2. 11 Mall Road - Game On & Loretta's Last Call

PLANNING BOARD AGENDA FOR JANUARY 13, 2026 - 7:00 PM

Below please find our responses comments discussed in our December 9, 2025 meeting and at the PB meeting. Below please find each comment followed by our response in **bold**.

Enclosed please find our responses to your letter dated December 19, 2025. Below please find each comment followed by our response in **bold**.

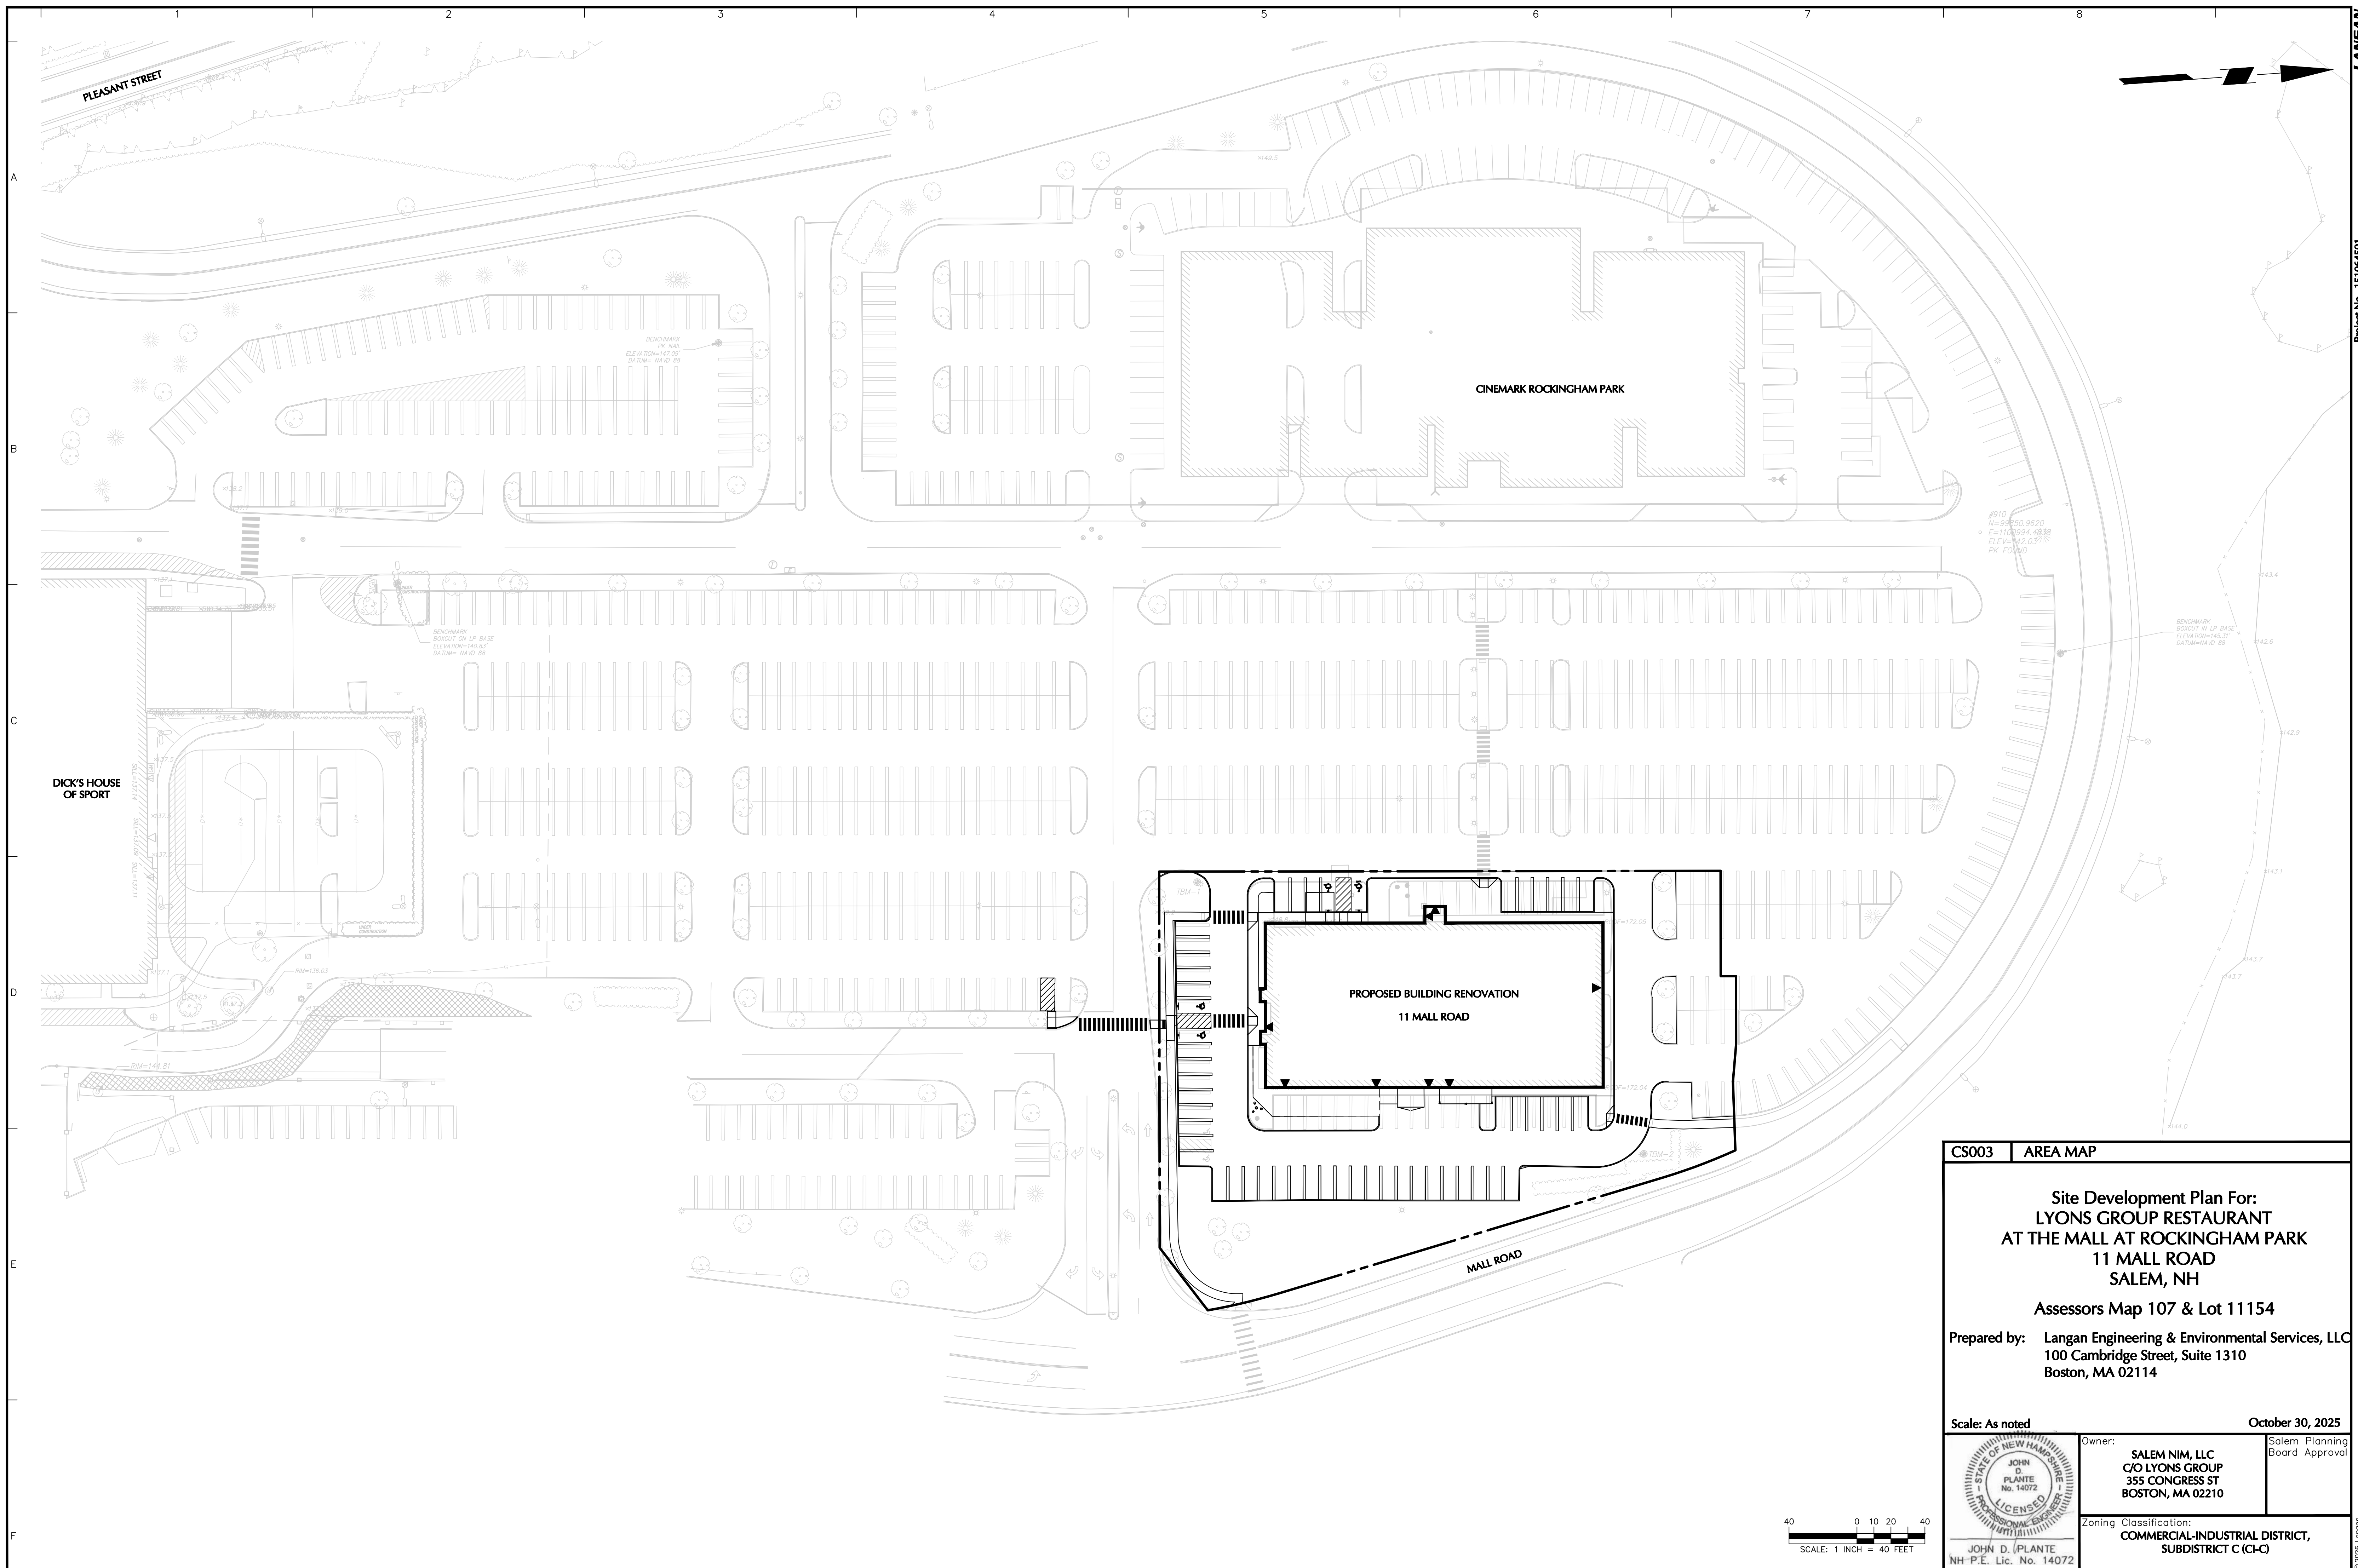
- Eliminate zoning table on Existing Conditions Plan

COMMENT RESPONSE: Zoning Table has been removed from VT901.

CS101 EXTERIOR SITE PLAN

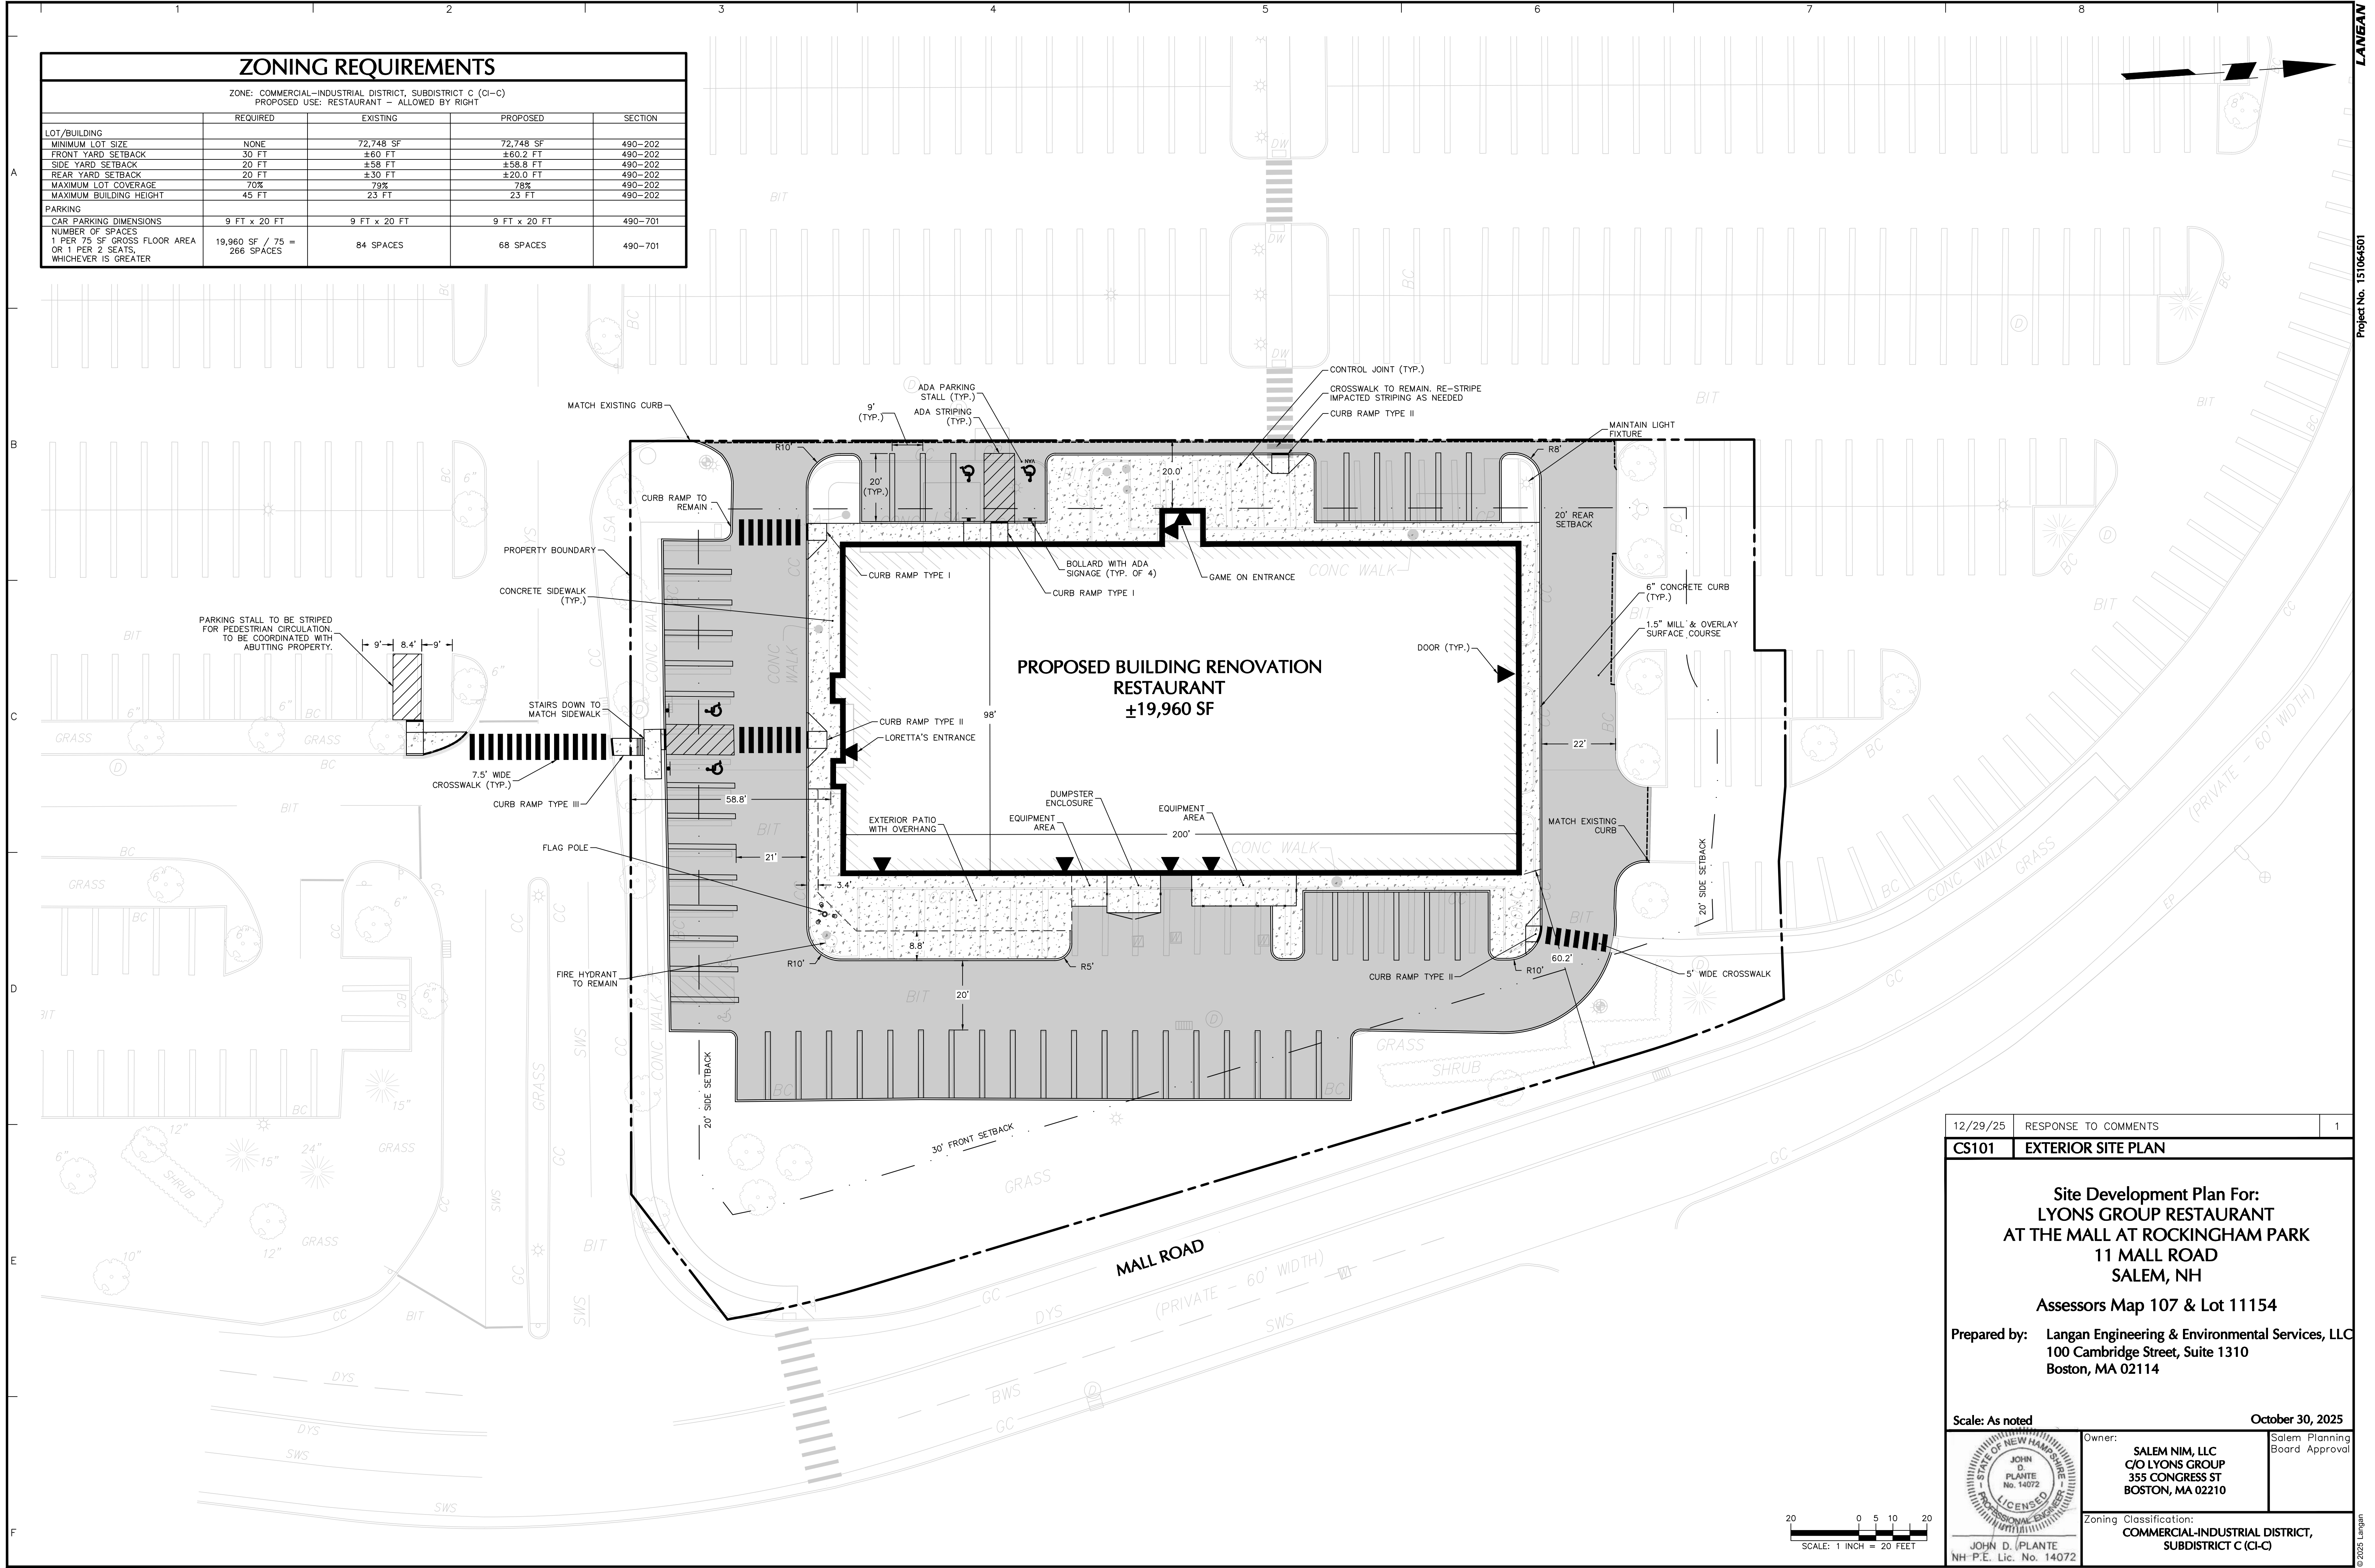
- Add pedestrian connection to north sidewalk

- Add tip down at ADA spaces to ped. connection to south

- Add dimension of striped space to south

COMMENT RESPONSE: Curb ramp with crosswalk has been added to the plans. Please see CS101.

COMMENT RESPONSE: Tip down to ADA spaces has been added to south sidewalk connection, as seen on CS101.

COMMENT RESPONSE: Dimensions have been added to restriped southern parking area, seen on CS101.

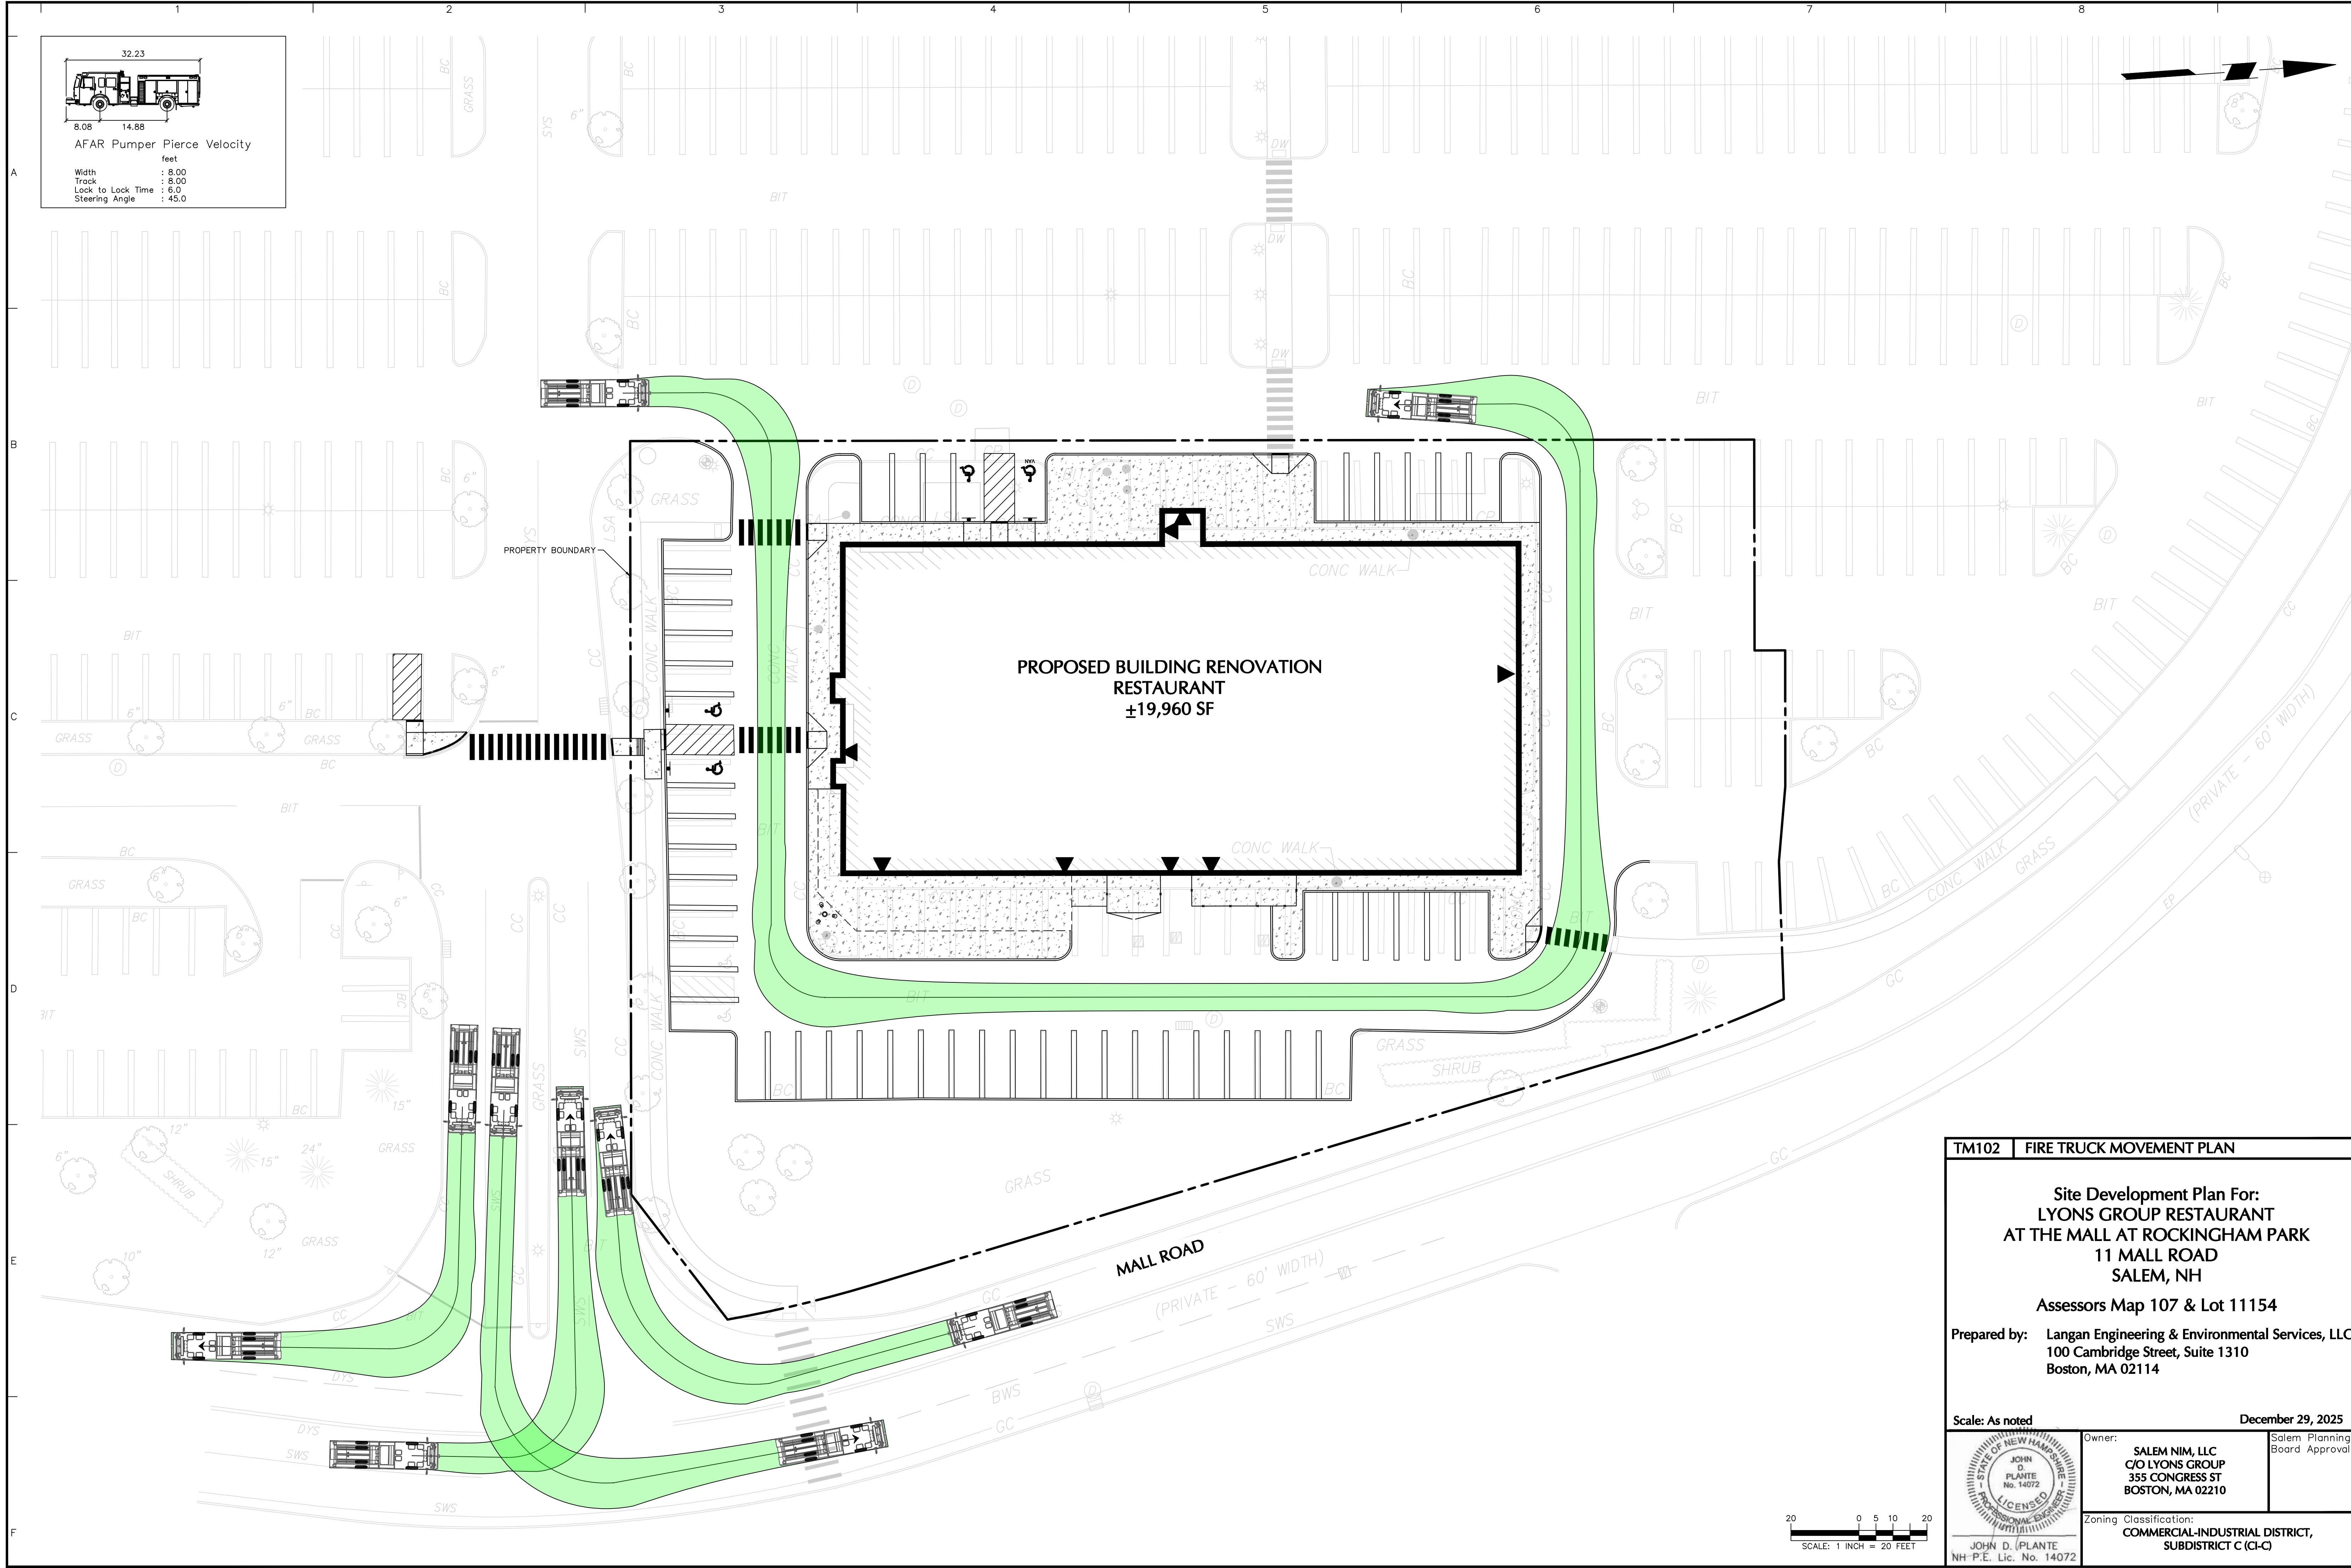
COMMENT RESPONSE: Southern sidewalk now has a connection to the parking lot. This sidewalk connects to a crosswalk to cross at the intersection where they can head north to other pathing.
 - Submit truck turn plan for trash pickup

COMMENT RESPONSE: Truck turning plan has been added to the set on TM101.
